Access Compliance Report Public Rights-of-Way (Curb Ramps)

Main Street: AVENDALE_BLV		Cross Street: S_SELLAS_RD		Location:	S
ADA ID: RPRK211109131654	Ramp Type: Type 4 - Parallel	Initial Pass/Fail: Fail	Overall Compliance: No	Severity Score:	15

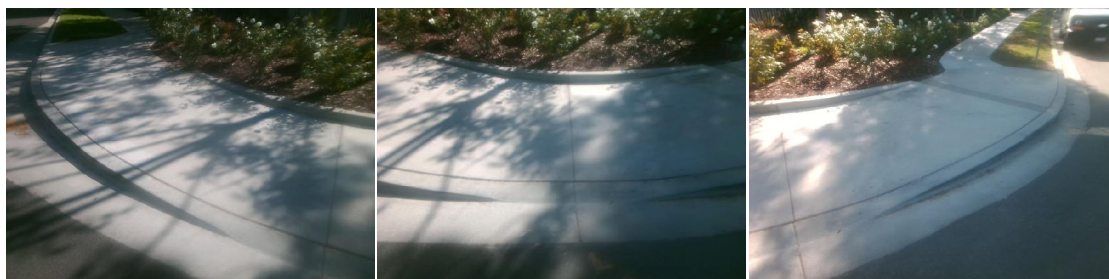
Compliance	Description	Data	Compliance	Description	Data
N/A	Ramp Length LT (in)	130	N/A	Ramp Length RT (in)	130
Yes	Ramp Width LT (in)	89	Yes	Ramp Width RT (in)	89
No	Ramp Run Slope LT (%)	9.6	Yes	Ramp Run Slope RT (%)	0.5
Yes	Ramp Cross Slope LT (%)	0.1	Yes	Ramp Cross Slope RT (%)	0.1
N/A	Landing Present	N/A	N/A	DWS Provided	N/A
N/A	Landing Length (in)	N/A	N/A	DWS Contrast	N/A
N/A	Landing Width (in)	N/A	N/A	DWS Length (in)	N/A
N/A	Landing Run Slope (%)	N/A	N/A	DWS Full Width	N/A
N/A	Landing Cross Slope (%)	N/A		DWS Offset Type	N/A
N/A	Landing Movement Obstructed?	N/A	N/A	DWS Offset Left (in)	N/A
	Landing Movement Type	N/A	N/A	DWS Offset Right (in)	N/A
N/A	Landing Shared	N/A			
N/A	Clear Space	Yes			
N/A	Clear Space To Crosswalk (in)	48			
N/A	Marked Crosswalk 1	Yes	N/A	Marked Crosswalk 2	Yes
	Crossing 1 Direction	NE		Crossing 2 Direction	NW
	Marked Crosswalk 1 Width (in)	120		Marked Crosswalk 2 Width (in)	120

Remove & Replace Curb Ramp With Two New Directional Ramps or Equivalent.

R304.3.2, STD 1115
